## ORIGINATION FORM

Proposed Revisions to a Standard Plans Index  
(Please provide all information — Incomplete forms will be returned)

Index Number: 515-080

Index Title: Pipe Guiderail (Steel)

Sheet Number (s): 5

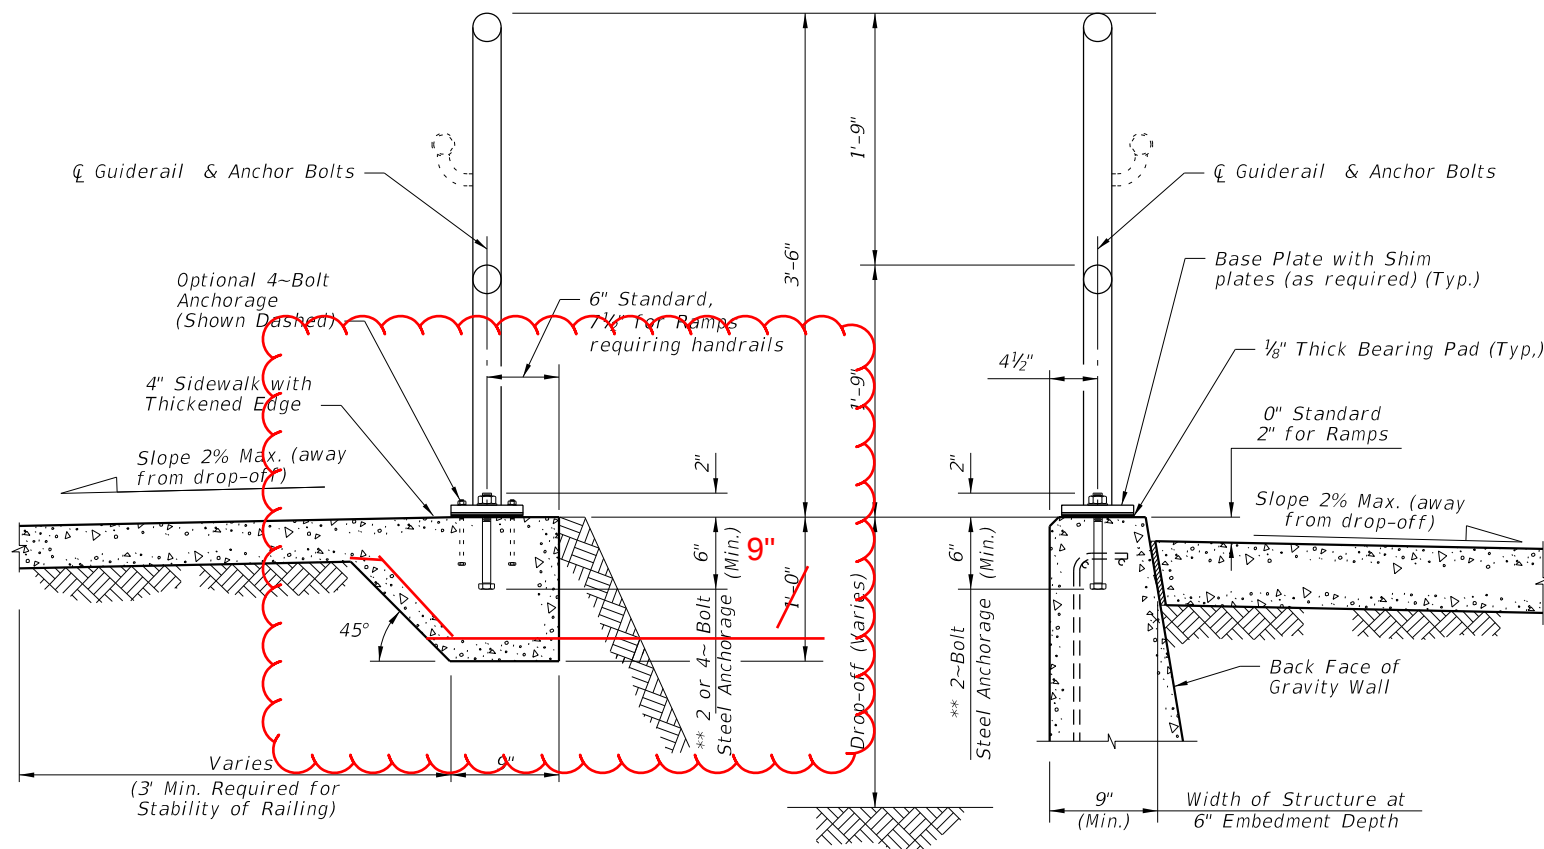
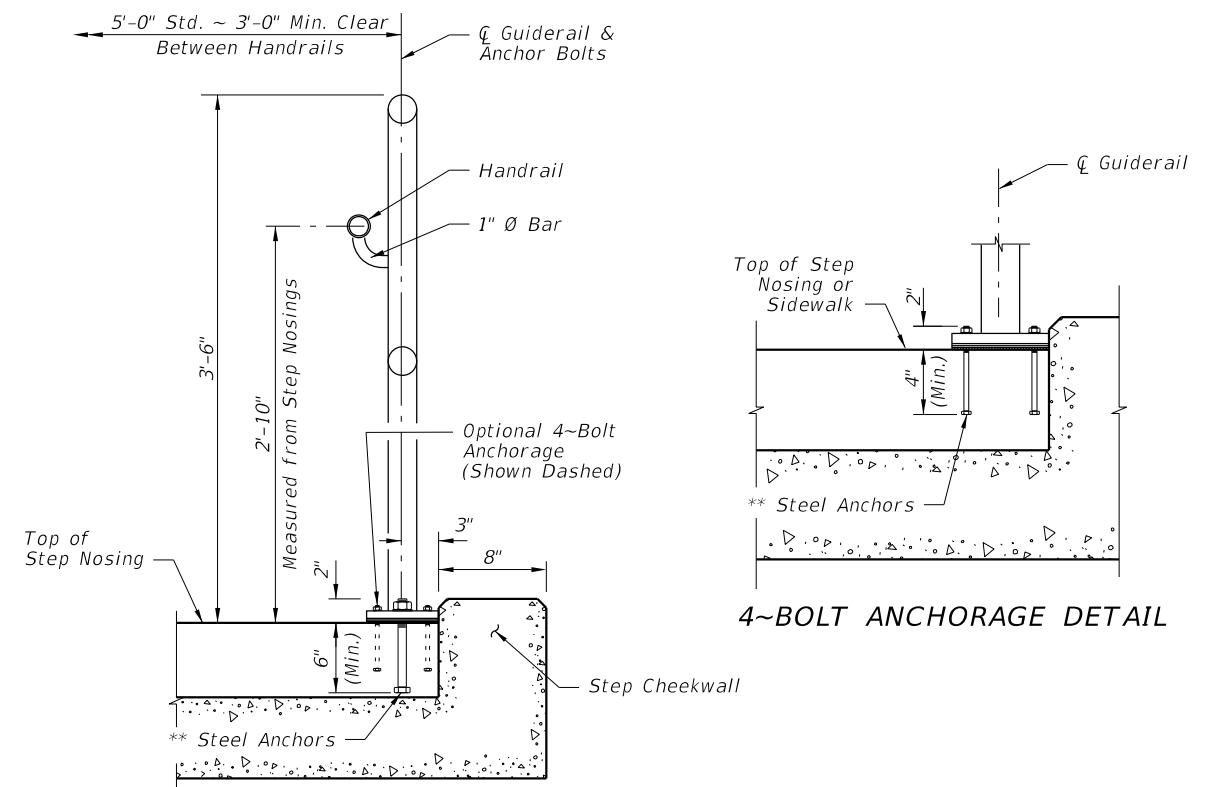
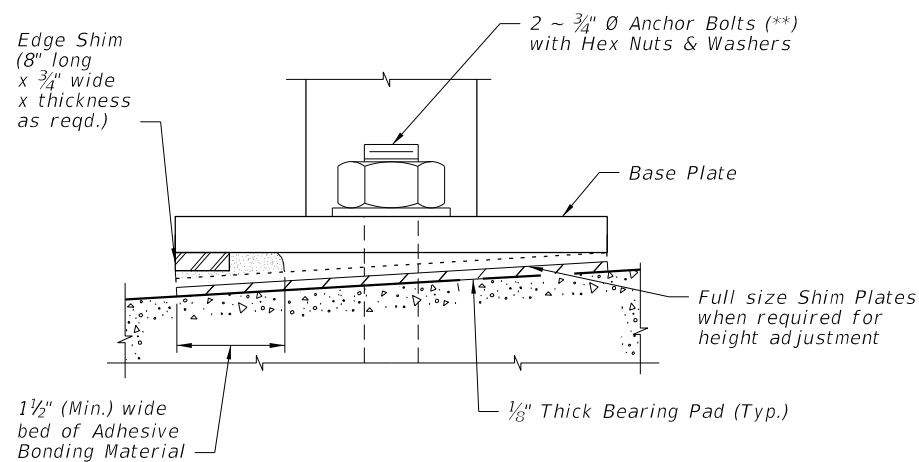
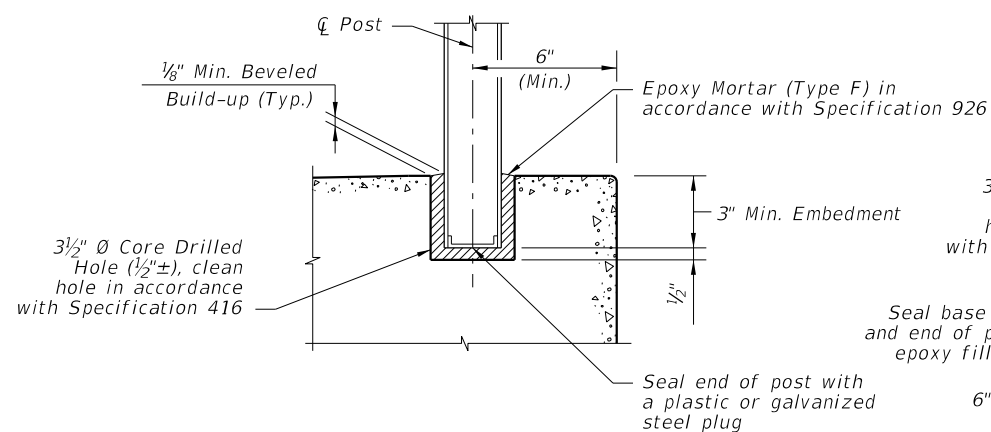
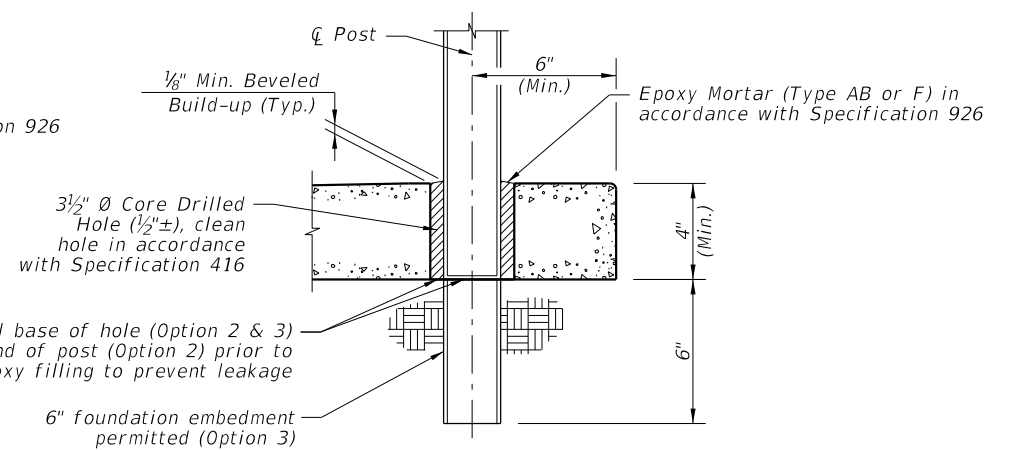
Change edge beam of sidewalk to 9" deep.

Due to research, embedment was reduced to 6"; therefore, the depth can be reduced to 9".
